Access Compliance Report

Public Rights-of-Way

Intersection ID: 50595	Main Street: BENDING_BRANCH_RD	Cross Street: GRAY_WILLOW_RD	Location: NE
ADA ID: 17D335CBE703	Ramp Type: Perp	Initial Pass/Fail: Pass	Overall Compliance: No
Severity Score: 5			
Codes/Mitigation Info/Possible Solution		Field Measurements/Component Compliance

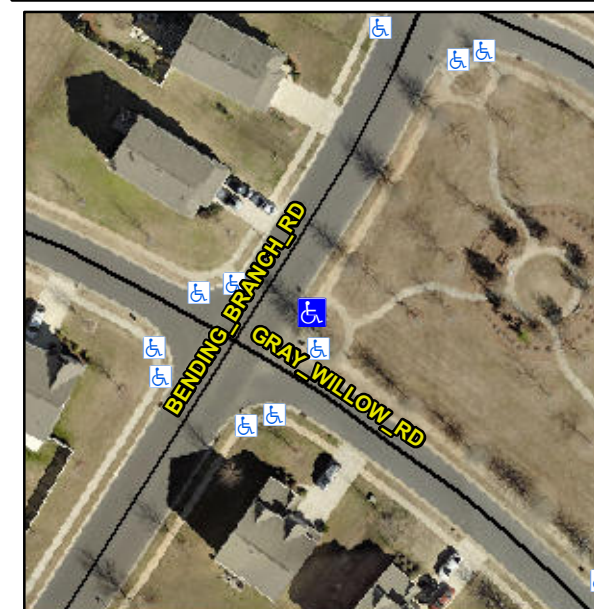
**Remove & Replace Entire Ramp.
Remove & Replace Gutter.**

**Not Found, R304.2.2-Perp, R304.3.2-
Para, R304.5.3, R302.7, R304.5.4**
